Tentative Minutes of the MAC/PHY Interface Ad-Hoc Group

Interrum meeting
Oshawa, Ontario, Canada
May 9-12, 1994

Suggested Revision:

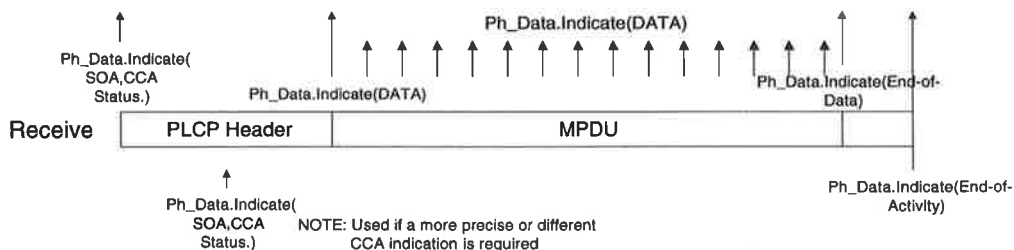
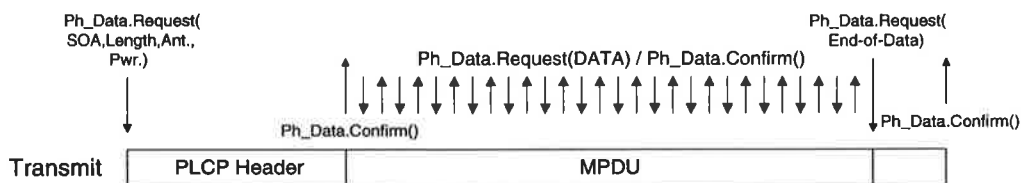
Larry van der Jagt presented suggested revisions to 93/20b0 (Draft Standard) section 7. -- Interface Primitives.

Ph_Data.Request(CLASS, DATA)

CLASS	DATA
Start-of-Activity	Not Defined
Data	Data
End-of-Data and Activity	Not Defined

CLASS	DATA
Start-of-Activity	Transmit Parameters (e.g. Antenna, Tx Power, Length)
Data	Data
End-of-Data and Activity	Not Defined
